Access Compliance Report

Public Rights-of-Way

Intersection ID: 53888	Main Street: LOVELAND_DR	Cross Street: PAW_VALLEY_LN	Location: SW
ADA ID: 894ECFC41E9A	Ramp Type: PerpDiag	Initial Pass/Fail: Fail	Overall Compliance: No
Codes/Mitigation Info/Possible Solution		Field Measurements/Component Compliance	
Severity Score: 8.75

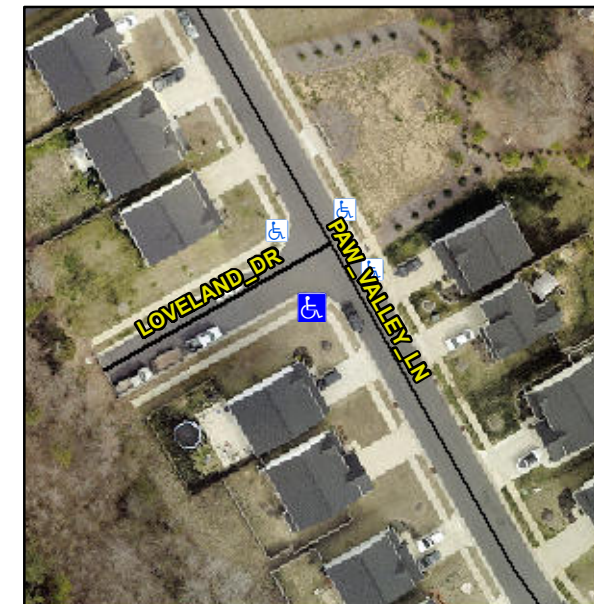
Not Found, R304.5.1

Compliance	Description	Data	Compliance	Description	Data
N/A	Ramp Length (in)	48.0	Yes	Ramp Slope (%)	5.0
No	Ramp Width (in)	47.0	Yes	Ramp XSlope (%)	1.0
N/A	Flare Type LT	N/A	N/A	Flare Type RT	N/A
N/A	Flare Slope LT (%)	N/A	N/A	Flare Slope RT (%)	N/A
N/A	Flare Traversable LT?	N/A	N/A	Flare Traversable RT?	N/A
N/A	Landing Length (in)	N/A	N/A	DWS Provided?	N/A
N/A	Landing Width (in)	N/A	N/A	DWS Contrast?	N/A
N/A	Landing Slope (%)	N/A	N/A	DWS Length (in)	N/A
N/A	Landing X Slope (%)	N/A	N/A	DWS Full Width?	N/A
N/A	Landing Curb? (Y/N)	N/A	N/A	DWS Offset (in)	N/A
N/A	Shared Landing?	N/A			
N/A	Gutter Ponding?	N/A	N/A	Gutter Slope (%)	N/A
N/A	Gutter Lip Ht (in)	N/A	N/A	Gutter X Slope (%)	N/A
N/A	Painted X Walk1?	No	N/A	Painted X Walk2?	No
	X Walk 1 Direction	To E		X Walk 2 Direction	To N
N/A	X Walk 1 Width (in)	N/A	N/A	X Walk 2 Width (in)	N/A
	X Walk 1 Slope (%)	4.4		X Walk 2 Slope (%)	3.1
	X Walk 1 X Slope (%)	5.0		X Walk 2 X Slope (%)	5.5

Remove & Replace Curb Ramp With Two New Directional Ramps or Equivalent.
